Construction News - Engineering

EFACEC RMUs – Transition to 22kV Fuses in 11kV units

Figure 1 Bent rear fuse contact tulip in-situ

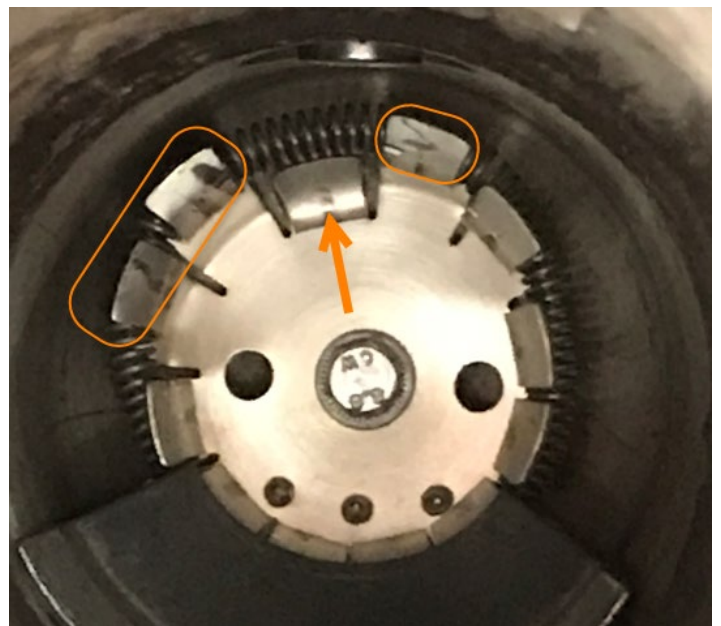
There have been several bent rear fuse contact tulips found in the EFACEC RMUs used in the Tyree padmount substations. Whilst these bent tulips are not causing a serious concern now, the poor contact is resulting in partial discharge, which will lead to operational issues in the long-term. From investigations undertaken, the damage is believed to be caused from the design of the 11kV fuse extenders.

An example of the damage to the rear fuse cap can be seen pictured to the right. The worst area of damage is visible at the top of the fuse contact where the finger has been bent inwards (orange arrow). Other key signs of damage are where the fingers have been splayed outward as indicated by the orange circles.

After considering these options, Engineering has established adopting 22kV fuses and abandoning the use of fuse extenders for 11kV units to be the most suitable option.

Any new RMUs will not be supplied with fuse extenders. They will be fitted with 22kV fuses when commissioned, even if the RMU is to be used in 11kV applications.

In the case of already installed RMUs, when a fuse blows, all fuses must be replaced as per standard practice but will now be replaced with 22kV fuses even in the RMUs is part of the 11kV network.

Before inserting the new fuses, the existing contacts are to be examined for damage, if damaged is found an eMWL for the replacement of the rear fuse tulip contacts must be raised. If an ASP identifies any damage to a unit, contact Tyree to report it. Once the new 22kV fuses have been installed, all fuse extenders are to be disposed of as scrap metal.
